Subject: Project name CRAFTMARK  
Project site address 5239 Cape Myrtle Court  
Permit # B16005391 SDP # \_\_\_\_\_  
Other information pertinent to this project \_\_\_\_\_

Walnut Creek - Lot 144  
 5039 Cape Myrtle Court  
 Ellicott City, MD 21042

FOUNDATION / BASEMENT PLAN

**PERMIT SITE PLAN**  
**LOT 144**  
 5039 CRAPE MYRTLE COURT  
**WALNUT CREEK**

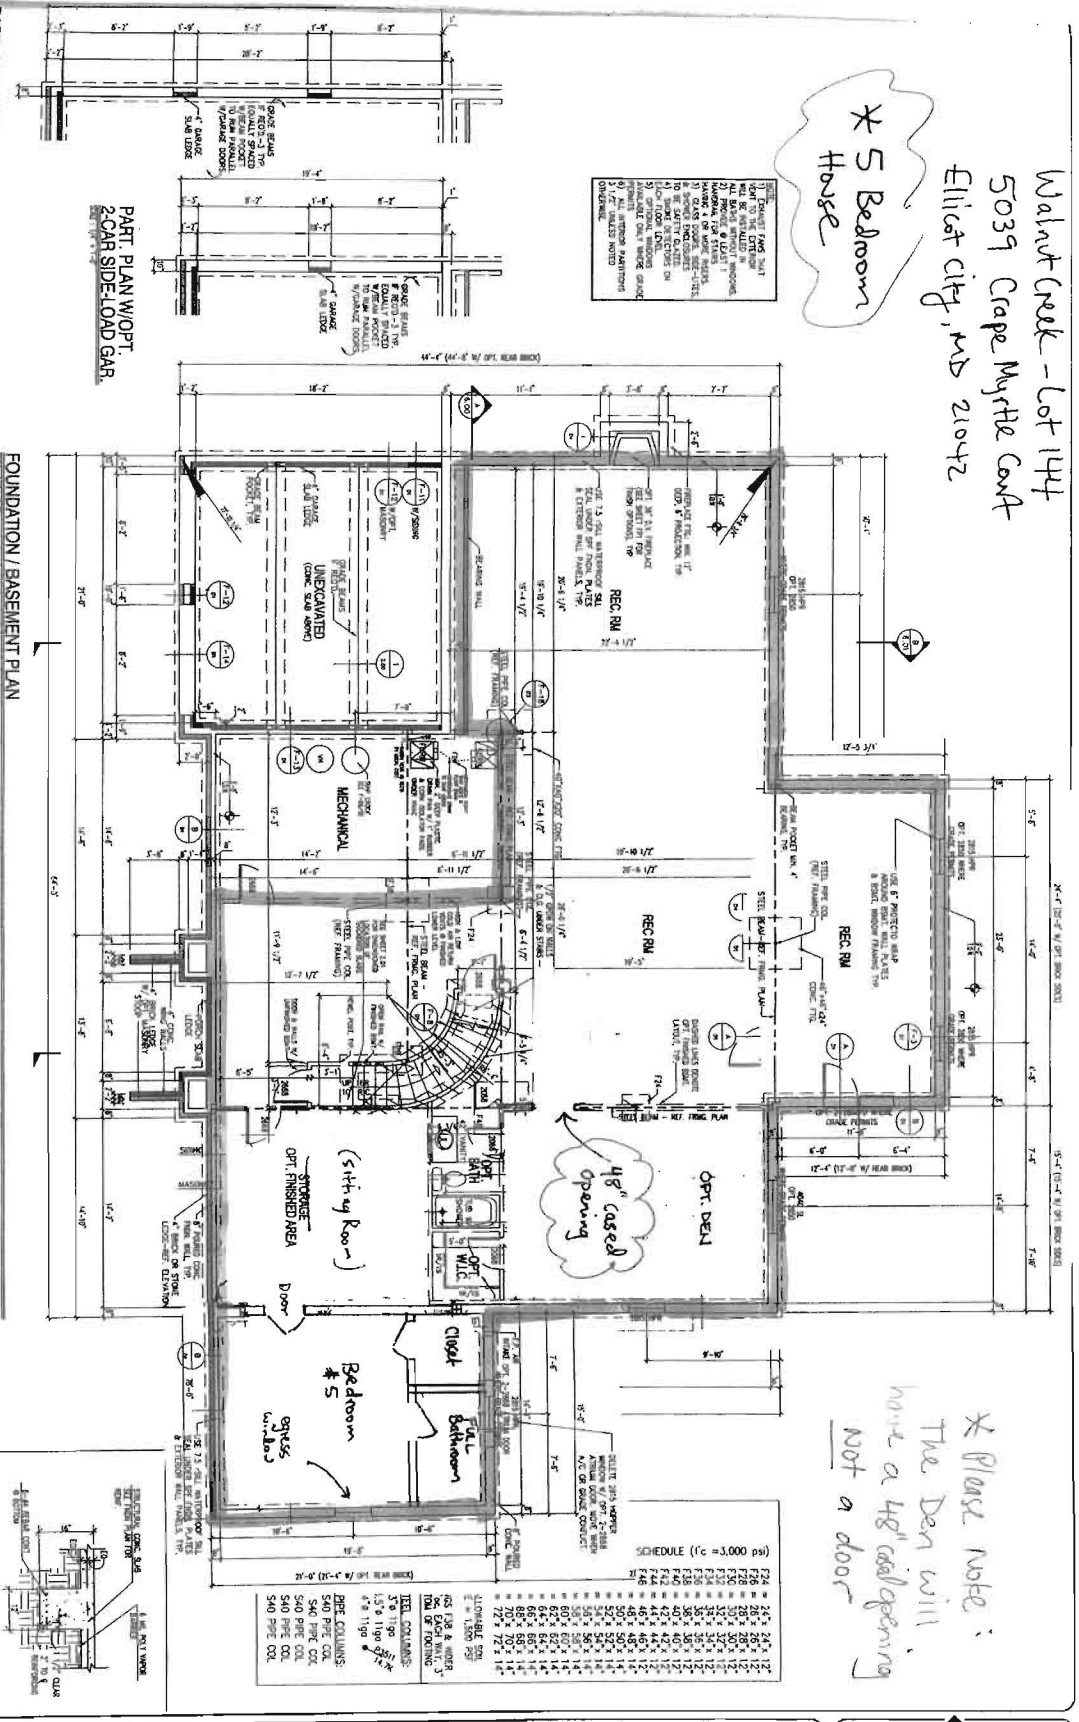
\* Please Note:  
 The Den will  
 have a 48" wide opening  
 not a door

If that is the case than I need new floor plans submitted to Dept. of Inspections, Licenses and Permits (DILP) showing the cased opening as a four foot wide opening with no door. Have DILP send us one of the copies.

REVISED

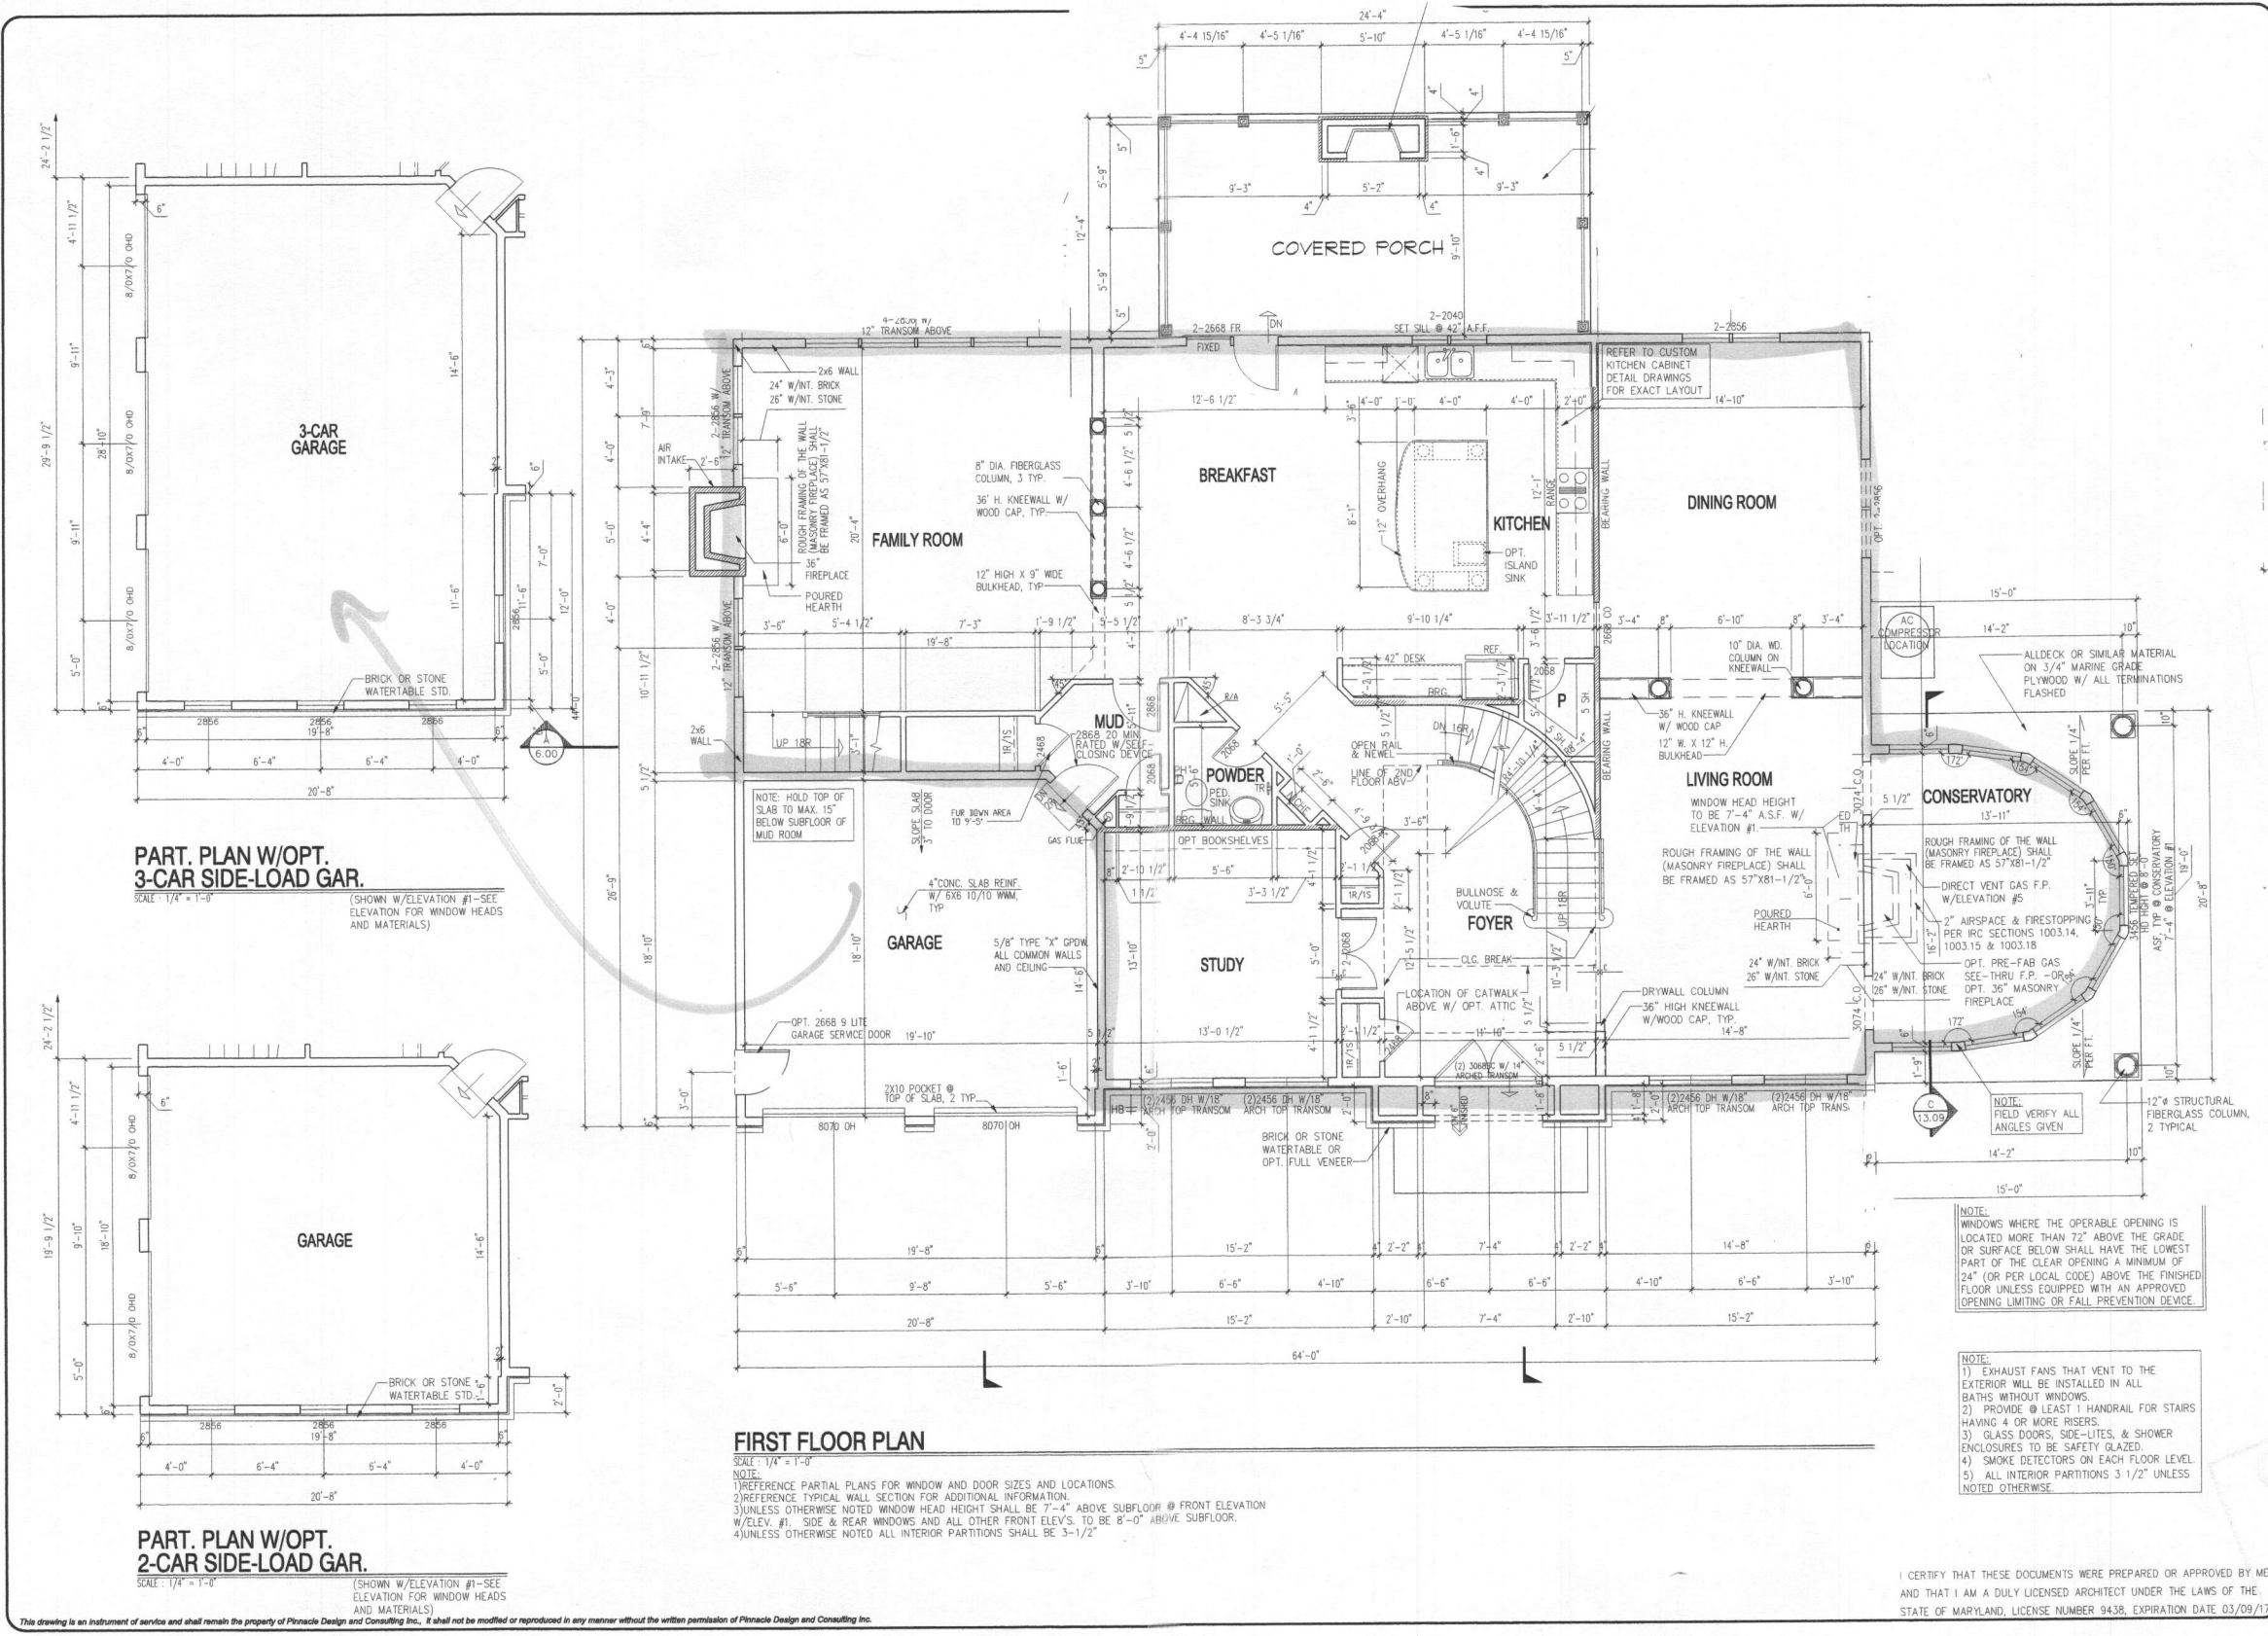
The full bath in the unfinished storage area creates a potential future problem if the den is set up like a bedroom as you mentioned. If it is finished, it would also count as a bedroom because of the full bath or full bath rough-in, which would put the total to 6. If you want to keep the floorplan as-is, we would send you a memo and keep it in the file that the storage room must remain unfinished or one of the bedrooms converted to a non-bedroom before approving a building permit to finish that room. You can choose this route if you want. If you choose to do the 4' wide opening to the den, you would just need to revise the BP through DILP to specify the change.

I have some questions about the submitted floor plans for Walnut Creek Lot 144. Does the Opt. Den in the basement have a four foot wide opening near the rec room bump out? Also can you confirm whether or not the Storage Opt. Finished Area and Storage room will be finished areas and if they are two separate rooms? Let me know if you have any questions.

will ensure I have the 4' cased opening into the "den" in the rear of the house which will allow this to truly be classified as a den and NOT a bedroom. This brings me to the 5 bedroom max allowable. The way I submitted the highlighted diagrams is an accurate representation of what I hope to build except I forgot to label the 4' cased opening into the den, I think. Please let me know if I am in compliance with your requirements.
